**0.0 Planning Application PLN19/0086 at 58-64 Hall Road, Warrandyte South for demolition works and the use and development of the land (including buildings and works) for a secondary college (Year 9 campus of Donvale Christian College) and vegetation removal.**

File Number:	IN19/677
Responsible Director:	Director City Planning and Community
Applicant:	Peter Weatherlake for Brand Architects
Planning Controls:	Rural Conservation Zone Schedule 3(RCZ3), Bushfire Management Overlay (BMO), Environmental Significance Overlay Schedule 3 (ESO3), Heritage Overlay Schedule 219 (HO219)
Ward:	Mullum Mullum
Attachments:	1 Legislative Requirements 2 Development Plans 3 Locality Map 4 Objectors Map

**Figure 4 - Proposed bus parking location in front of Warrandyte South Hall**

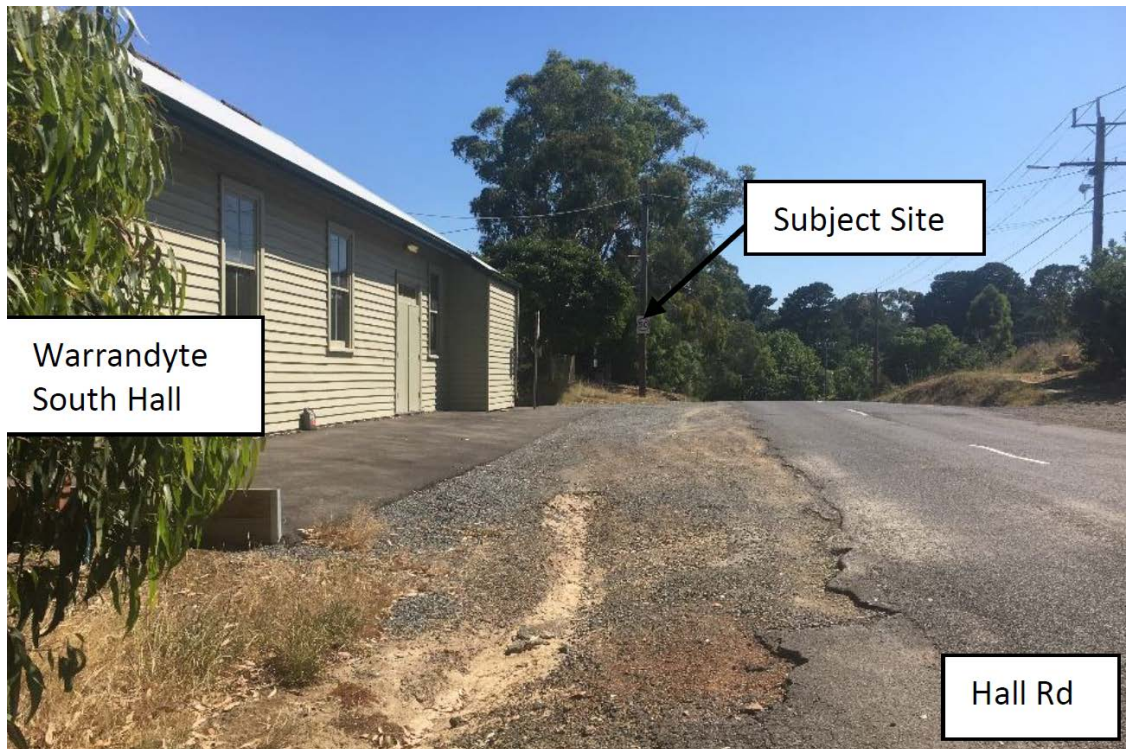
- 1.1 The Proposed On Street Bus Parking Plan (A003 TP3) enlarged to a suitable scale, and amended to show the following”
    - A bus ‘drop off’ bay located adjacent to the Community Hall with a concrete kerb outstand along the west side of Hall Road, adjacent to the bus parking bay. The kerb outstand is to prevent bus encroachment into the north access gravel driveway of the Community Hall;

- A concrete path along the west side of the proposed bus bay extended north to the existing footpath access to the school;
    - A road hump at the entrance of the carpark;

- The location and type of any bollards, signage and line marking;
    - No Stopping’ signs on the east side of Hall Road, adjacent to the proposed site;

- School ‘Speed Zone’ signs.
    - Buses must not be parked in the bus ‘drop off and pick up’ bay located adjacent to the Community Hall beyond the designated drop off and pick up times to the satisfaction of the Responsible Authority.

- 8.59 Council's engineers have supported the proposal subject to an amended Functional layout Plan which would address several concerns of the objectors: This requires the following to be implemented and will form part of conditions of approval:
